JULIAN SUBDIVISION

PLAT AMENDMENT

JULIAN SUBDIVISION PLAT - 22 JUNE 2017

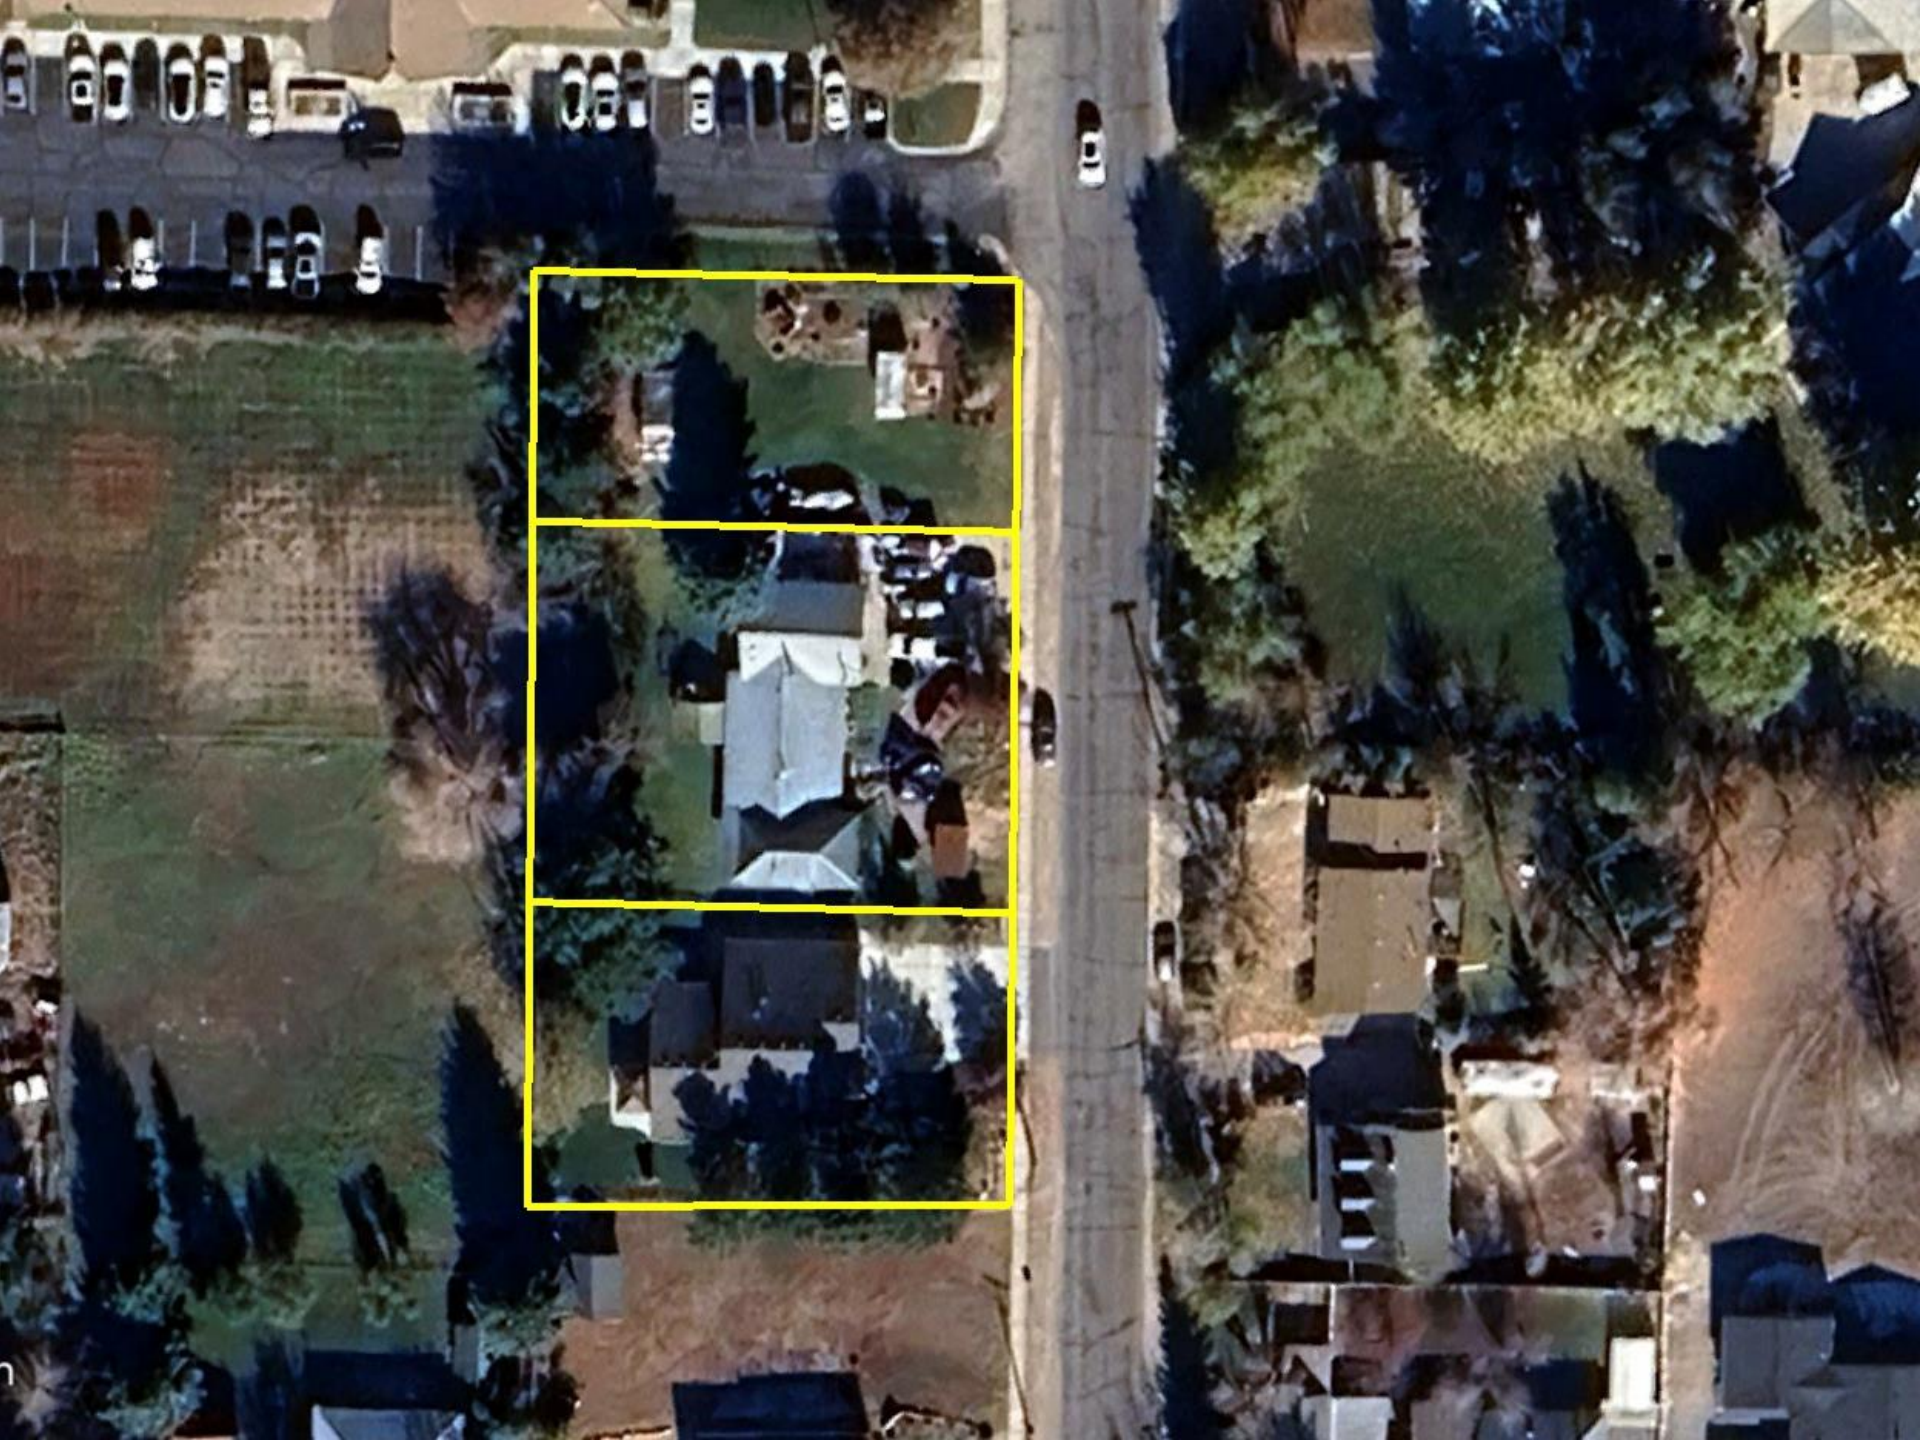
- Public Utility Easement: A public utility easement currently runs along the perimeter of the subdivision and along the shared lot line of Lots 1 and 2. The same public utility easement should run along the boundary between Lots 1 and 3 if the application is approved.
- Driveway: Per the existing Plat, the existing Lot 1 is limited to one driveway with a turnaround to avoid vehicles backing into traffic. A similar note should be placed on the plat for any new Lot 3, limiting Lot 3 to one driveway with a turnaround to avoid vehicles backing into traffic on Center Street.

- Water: Water shares for Lot 3 will have to be turned over to the City prior to the recording of any amended Plat. The lot will connect to the City's water line located under Center Street. A lateral will be needed for Lot 3
- Sewer Connection – A will serve letter from Midway Sanitation District and HVSSD will be needed for Lot 3. The lot will connect to Midway Sanitations District's line located in the area. A lateral will be needed for Lot 3.
- Secondary Water Connection – Lot 3 will connect to Midway Irrigation Company's secondary which is already servicing Lots 1 and 2. A lateral will need to be created for Lot 3.

- Sidewalks: Sidewalks run along the east side of the lots in the Subdivision.
- Sensitive Lands: Per the application, there are no sensitive lands, ditches, or canals on the property. The Midway City Geological and Hydrological Features Map does not show sensitive lands or water features at this location.
- Name: The original Plat denotes the subdivision name as the “Julian Subdivision”. The proposed amended Plat lists the name as the “RLJ Small Subdivision, Amending Lot 1 of the Julian Subdivision”. To avoid confusion, particularly for County rescue services, the name should remain “Julian Subdivision” and any amended plat revised accordingly.

1. Any amended plat will retain the name of the subdivision as the “Julian Subdivision”. If Lot 1 is divided into two lots, the northern lot shall be denoted Lot 3 and the southern remain Lot 1.

2. Lot 1 shall continue to be restricted to one driveway access with a turnaround. A similar note shall be placed on the plat for the newly created Lot 3, restricting to one driveway with turnaround to avoid backing into Center Street.

3. Public utility easements of 10 feet will run along each side of the property line between Lots 1 and 3.
4. Water shares sufficient for the new Lot 3 will have to be dedicated prior to recording of any amended plat.

5. Individual laterals for water and sewer have been installed by the City to the proposed lot. If the City Council approves the amendment, an irrigation lateral will also be installed. The developer shall reimburse the City for all costs incurred for the laterals prior to recording the amendment plat.
